TRENCH DATA	
TRENCH WIDTH	2
TRENCH INLET DEPTH	4
TRENCH BOTTOM DEPTH	9
DEPTH OF STONE	5
NUMBER OF TRENCHES	2
TOTAL TRENCH LENGTH	108
ABSORBENT AREA	540
DISTRIBUTION BOX LEVEL	<input checked="" type="checkbox"/>
BAFFLE IN DISTRIBUTION BOX	<input type="checkbox"/>

SEPTIC TANK DATA	
SEPTIC TANK	Existing
GALLONS	
MANHOLE RISER	N/A
6 INCH INSPECTION PORT	<input checked="" type="checkbox"/>
PUMP CHAMBER DATA	
PUMP CHAMBER GALLONS	
MANHOLE RISER	
ALARM	
PUMP PERFORMANCE TEST

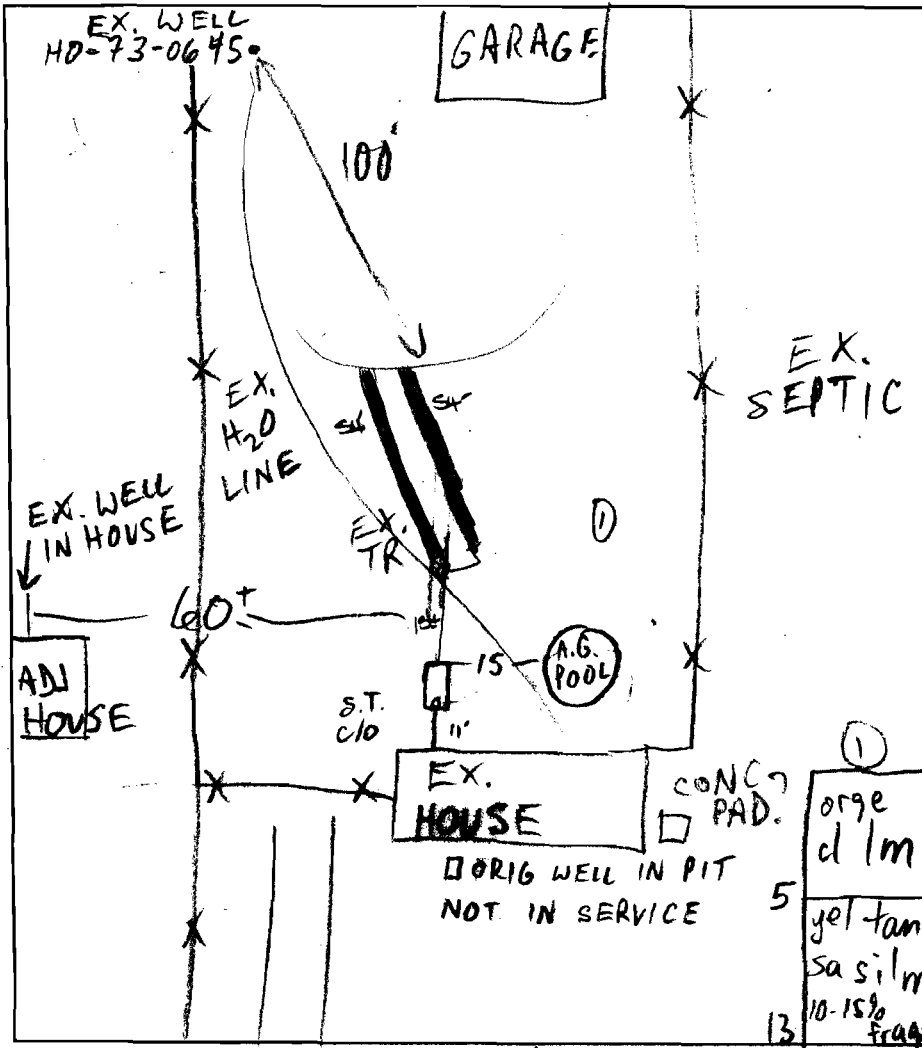
PRE-CONSTRUCTION INSPECTION: 2/13/01 OK TO START

INSPECTION COMMENTS: 2/20/01 final inspection - OK to cover all septic work. DEC
